KINGSTON PLACE - NO. 1
SITE PLAN

Table with 2 columns: Date (01/26/2021), Description (AMENDMENT 1 REVISIONS TO DETENTION POND AND FIRE LANE, LANDSCAPE PLAN AND BUILDING ELEVATIONS.)

KINGSTON PLACE
SHEET INDEX
SITE PLAN

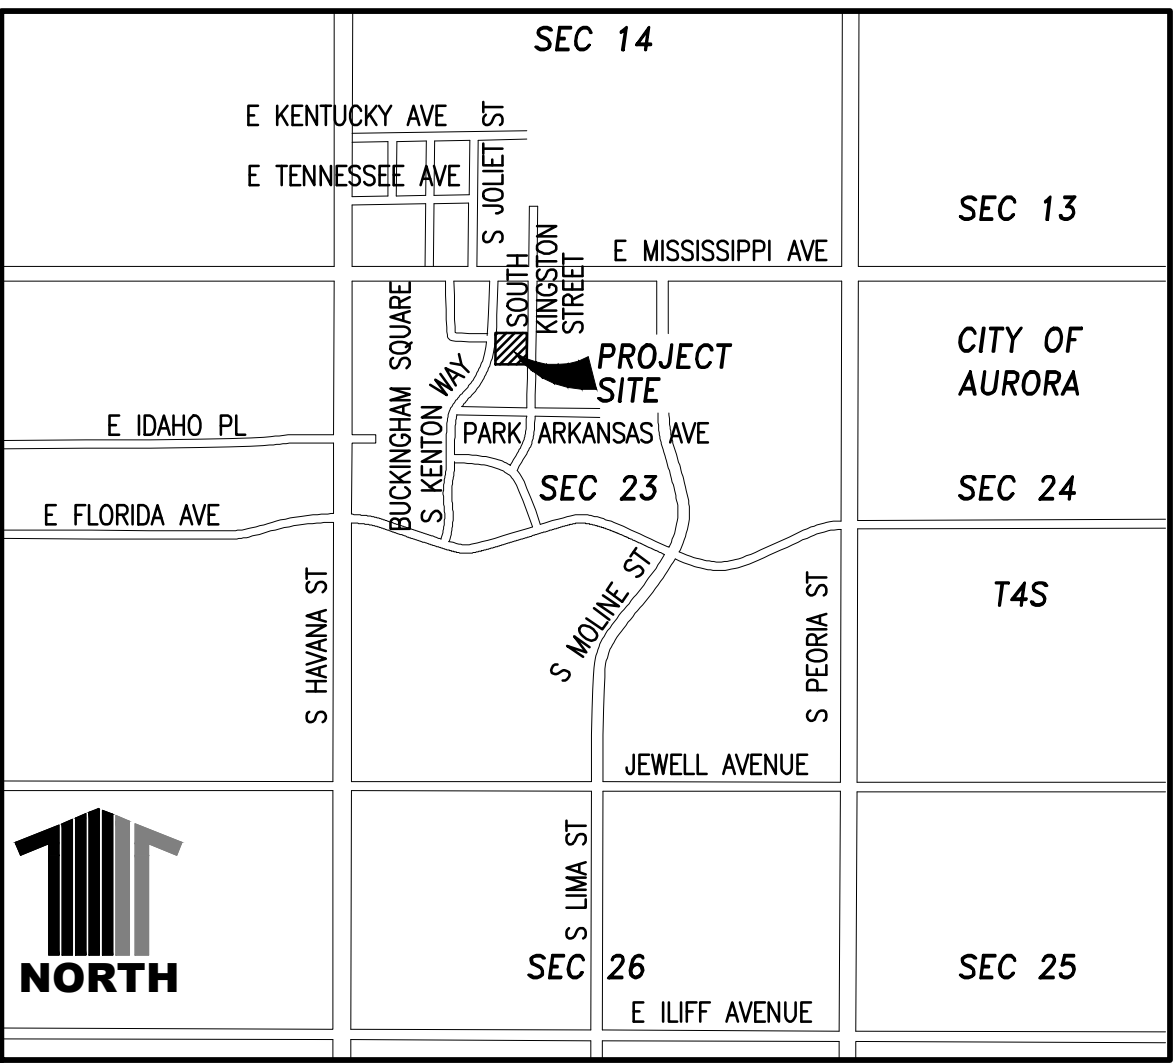
The site plan will not be approved by public works until the preliminary drainage letter/report is approved

NOTED, REVISED PDR HAS BEEN RESUBMITTED CONCURRENTLY.
